Item Name: Crosstube Aft High,214

DART AEROSPACE LTD		Work Order: 87840
Description: Crosstube High Aft (205/212)		Part Number: D212-664-201
Inspection Dwg: D212-664-241	Rev: D	Page 1 of 1

DRAWING NO. D212-664-241	TITLE CROSSTUBE ASSY (205/212 HI AFT)	REV. D	DART AEROSPACE LTD ENGINEERING ORDER		D.E.O. NO. D212-664-241-D-1	SHEET NO. SHEET 1 OF 2	SCALE NTS
DRAWN	CHECKED	MFG. APPR.	APPROVED	DE APPR.			
DATE 11.04.07	DATE 11.04.11	DATE 11.04.12	DATE 11/04/12	DATE 11.04.12

DRAWING NO. D212-664-241	TITLE CROSSTUBE ASS'Y (205/212 HI AFT)	REV. D	DART AEROSPACE LTD ENGINEERING ORDER		D.E.O. NO. D212-664-241-D-2	SHEET NO. SHEET 1 OF 1	SCALE NTS
DRAWN 92	CHECKED ASS	MFG. APPR. DS	APPROVED MAD		DE APPR. MAD		
DATE 11.07.15	DATE 11.07.20	DATE 11.07.21	DATE 11/27/21		DATE 11-07-21

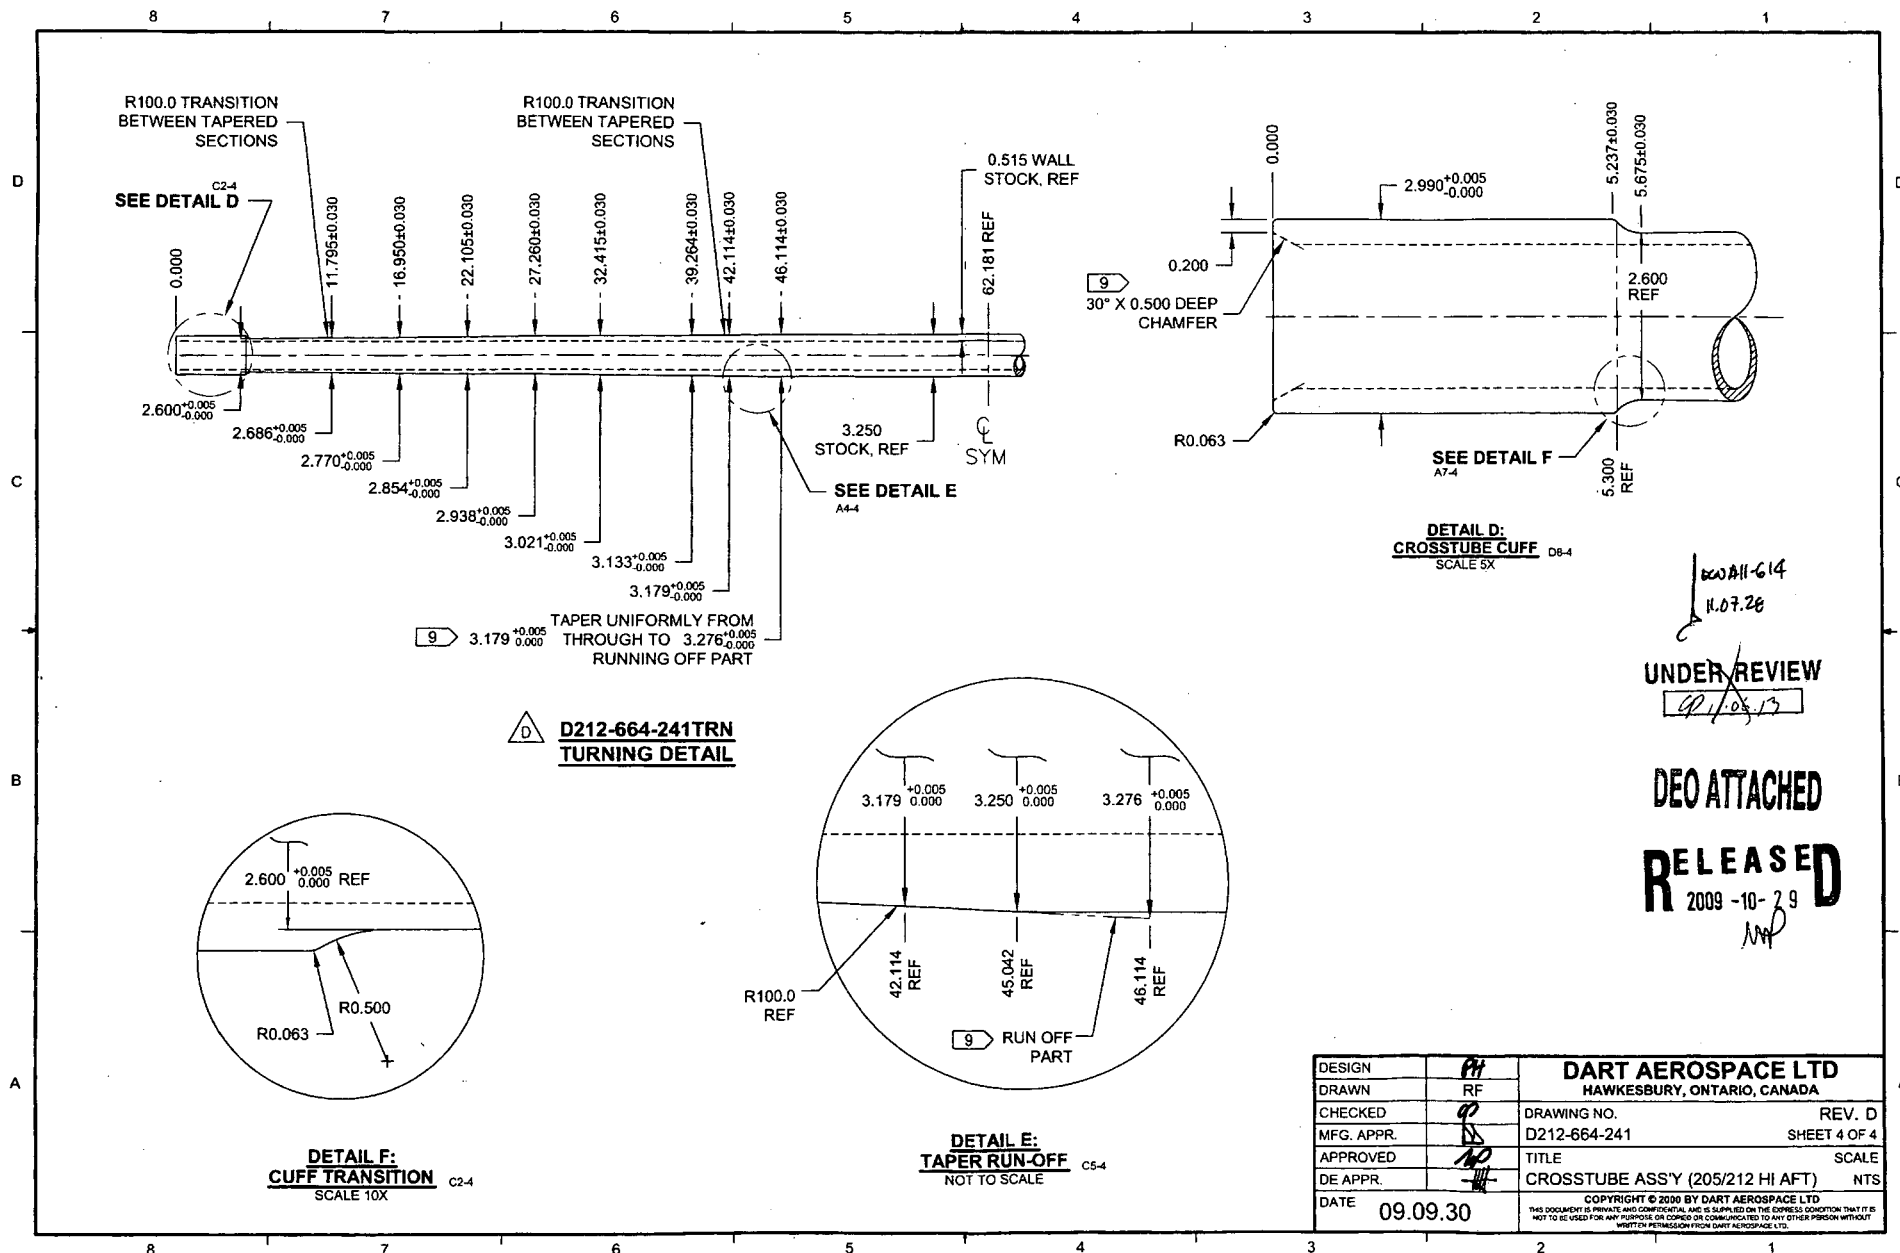
ADD AN INSPECTION WINDOW TO UNDERSIDE OF CROSSTUBE.

NOTES 2 OF SHEET 1 IS AMENDED AS FOLLOWS:

- 2) FINISH: CHEMICAL CONVERSION COAT PER DART QSI 005 4.1
PRIME INSIDE AND OUTSIDE PER DART QSI 005 4.2
MASK UNDERSIDE OF CROSSTUBE AS SHOWN (HATCHED AREA) AND
PAINT OUTSIDE PER DART QSI 005 4.2
REMOVE MASKING AND APPLY CLEAR COAT

- 2) FINISH: CHEMICAL CONVERSION COAT PER DART QSI 005 4.1
PRIME INSIDE AND OUTSIDE PER DART QSI 005 4.2
PAINT OUTSIDE PER DART QSI 005 4.2

CRUSHING OF D212-664-201

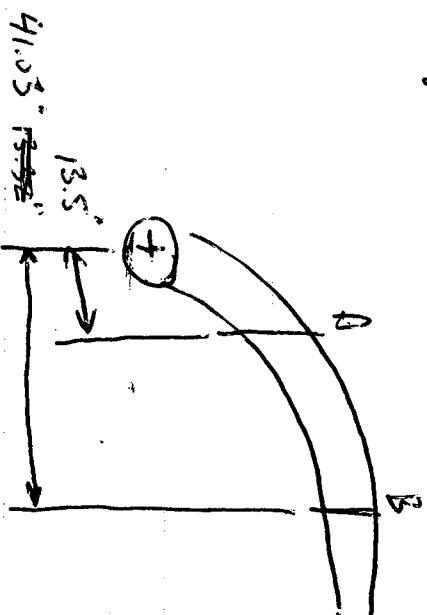
Side A	middle	Side B
Bending Passes	10	6	11
Crushing	6.4%		6.8%
Comments			
Side A = 6.4% crushing @ 10 passes			
Side middle = 6 passes			
Side B = 6.8% crushing @ 11 passes

Acceptability of 8% CRUSHING

Point A: $OD = 2.548 \text{ in}$ $OD = 2.492 \text{ in}$

Work Order: <u>89840</u>	DISPOSITION Rework <input type="checkbox"/> Scrap <input type="checkbox"/> Use-as-is <input checked="" type="checkbox"/> Work Order Update <input type="checkbox"/>	AGAINST DEPARTMENT/PROCESS			
Part No. <u>D 212-664-201B</u>		Skid-tube <input type="checkbox"/> Machining <input type="checkbox"/> Thermoforming <input type="checkbox"/> Large Fab <input type="checkbox"/>	Crosstube <input checked="" type="checkbox"/> Small Fab <input type="checkbox"/> Finishing <input type="checkbox"/> Composite <input type="checkbox"/>	Water Jet <input type="checkbox"/> Prod. Eng. Coord. <input type="checkbox"/> Rec/Store/Packaging <input type="checkbox"/> Supplier <input type="checkbox"/>	Engineering <input type="checkbox"/> Quality <input type="checkbox"/> Other <input type="checkbox"/>
NCR No. <u>12-1844</u>
